PRE-APPLICATION CONFERENCE NOTES

Summit Ridge (2020-005-PAC)

Date of Issue	February 20, 2020

Attachment C: ST-15 Local Access

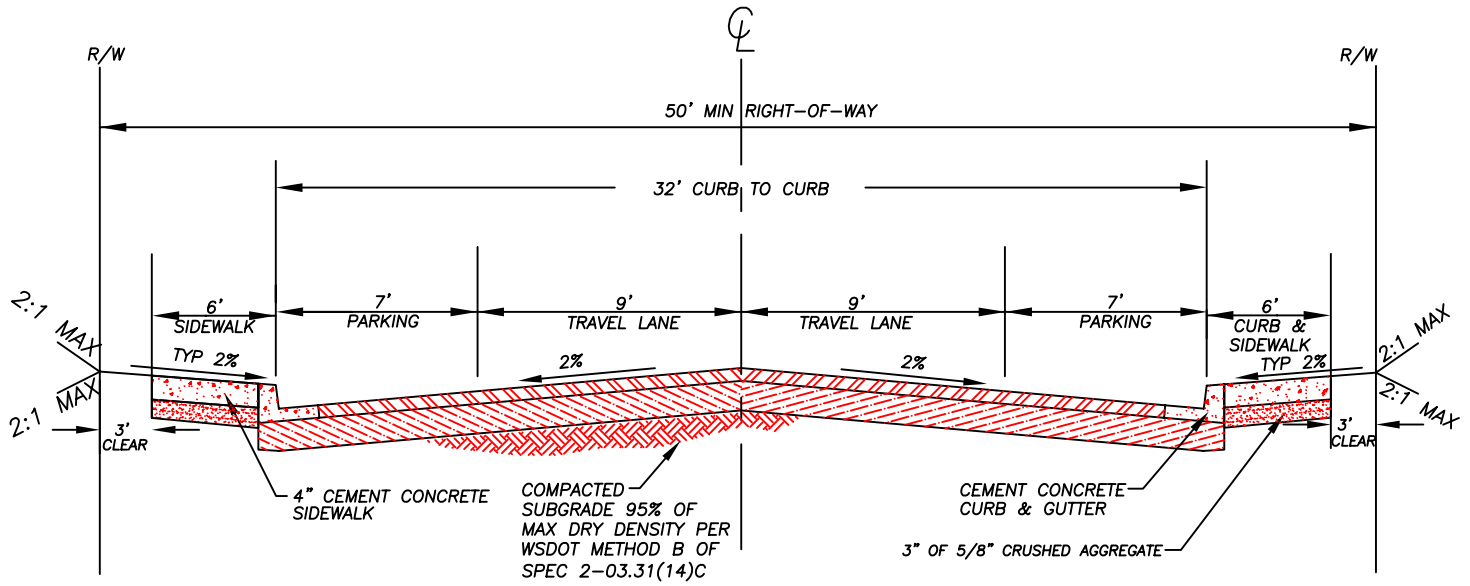
The applicant shall provide full street improvements on interior streets according to the City of La Center Local Access standard ST-15

CONCEPTUAL SITE LAYOUT FOR:

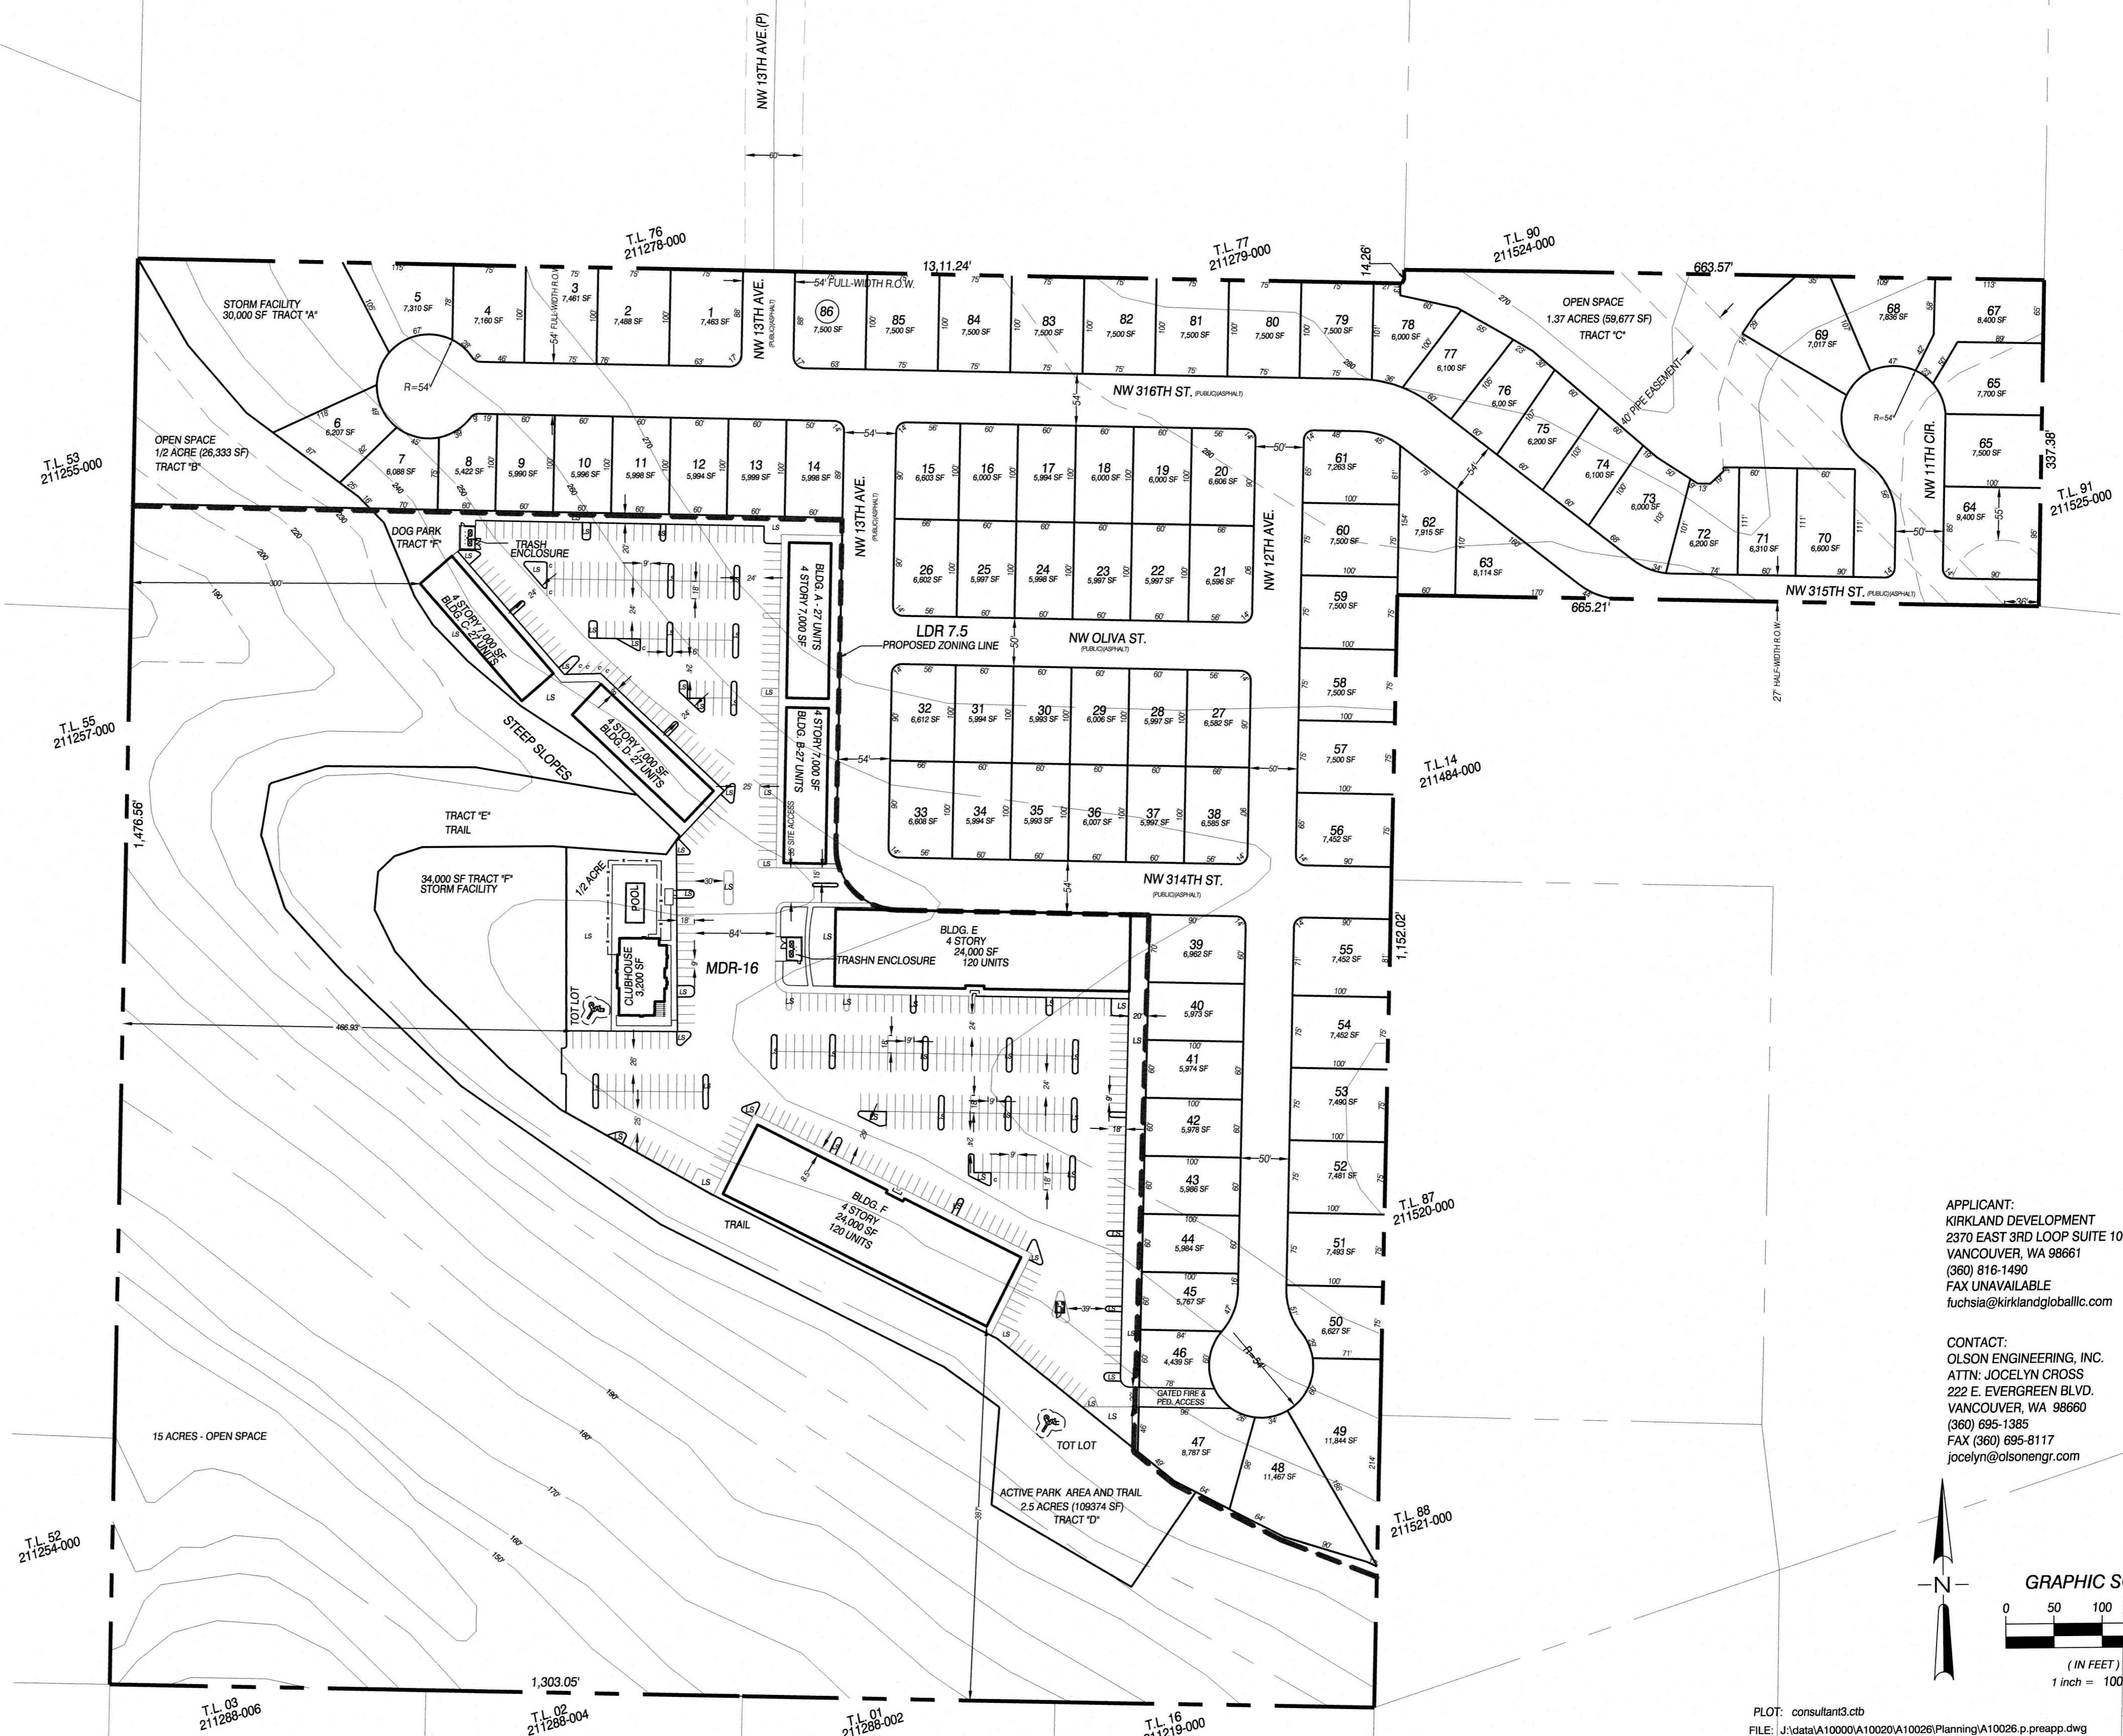
Center Road be classified as a Principal Arterial. The conceptual site layout shows that there is over 1300 lineal feet between 13th Avenue and the east boundary of the subdivision. Since the speed limit of La Center Road is 50 mph, access to La Center Road needs to be restricted. In order for the city to allow one access point for this development, a traffic study will need to justify the use of one access point.

Development in the LDR-7.5 zone must meet a minimum of 4 units per gross acre, minus right-of-way and critical areas. (See LCMC Table 18.210.080 – Density Requirements.). The applicant’s density calculations on the conceptual plan do not remove rights-of-way or critical areas in the LDR-7.5 portion of the site, but use a gross acre density calculation that does not comply with the code. Any variations in density from the code need to be approved through a development agreement. Alternatively, the applicant can adjust the design to meet the net density per acre calculation required in the code for the LDR-7.5 zone.

The applicant did not include specific information regarding the fencing, hedging, solid waste, lighting, noise, and landscaping requirements regulated by Chapter 18.245. The preliminary plat and site plan review applications must address these specific issues. Of note in this chapter are landscape buffer requirements which necessitate the provision of a five-foot L1 buffer between LDR-7.5 and MDR-16 development.
